31 October 2020

KUDUSBERG WEF ENVIRONMENTAL AUTHORISATION AMENDMENT: SPECIALIST IMPACT STATEMENT

Figure 7: Detail of known sites on Urias Gat, showing relative location of sites and buffers. The 500m farmstead exclusion zone applies only to turbine placement (RSA, 2020).

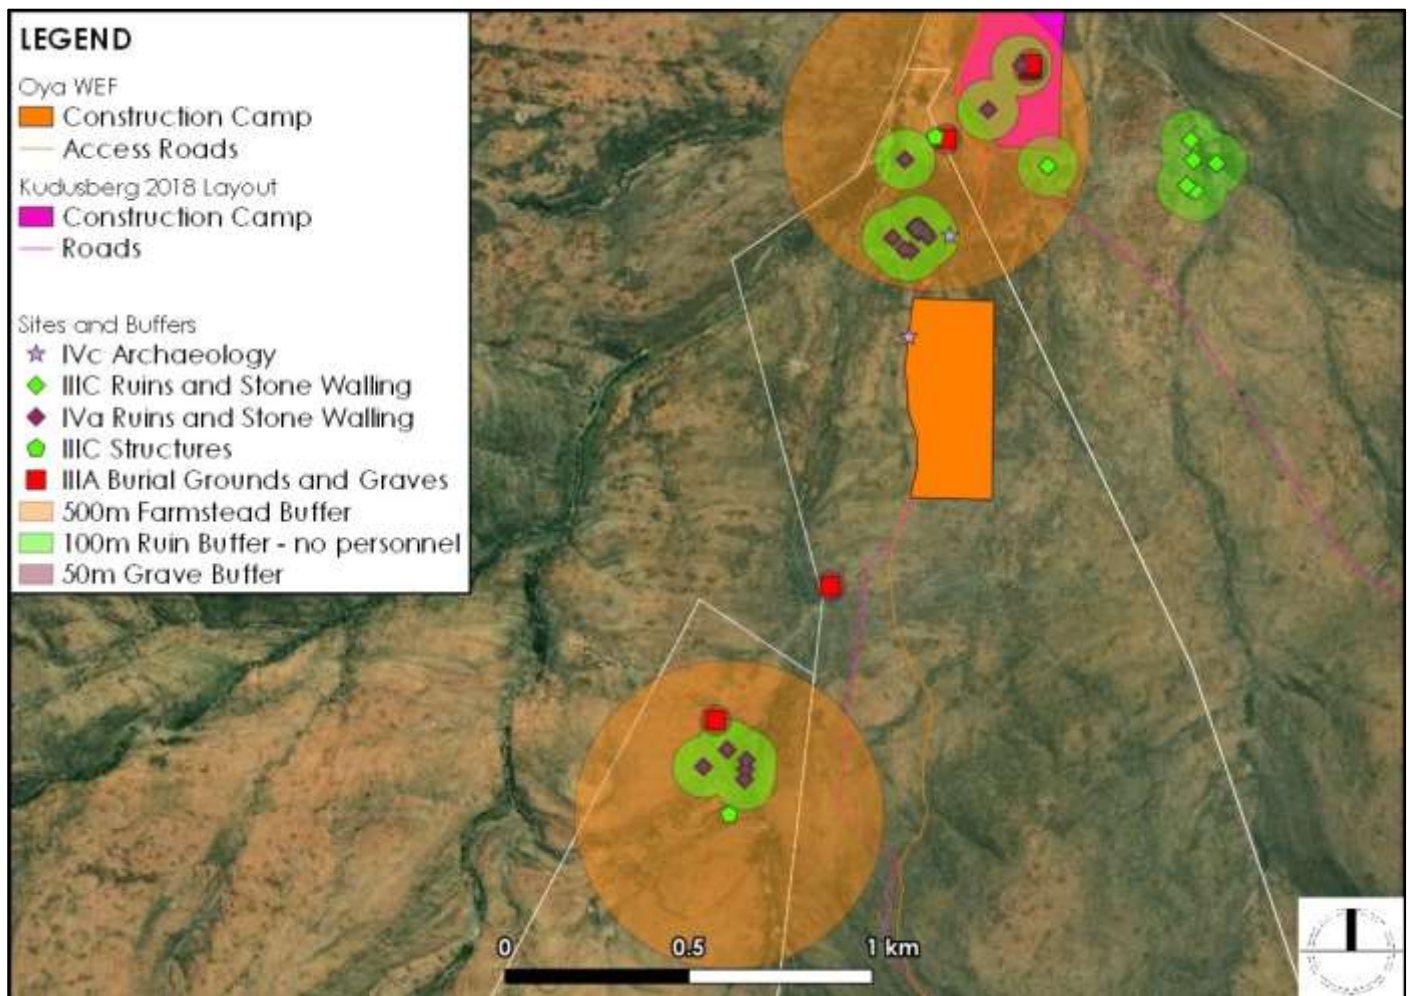
Due to the fact that the recommended walkdowns are being undertaken (part of separate standalone report), and appropriate mitigatory measures pertaining to heritage resources identified during the assessments have been recommended and provided in the EMP for implementation accordingly, it is not anticipated that the proposed changes will result in any further, different or greater impacts to heritage resources than those already identified in the 2018 HIA. All buffers previously imposed are respected and, in the case of the northern site clusters on Urias Gat, the new proposal increases the buffer between sites and infrastructure; no turbines are proposed for this area and these buffers pertain to road and construction infrastructure (Figure 6 and Figure 7 below).
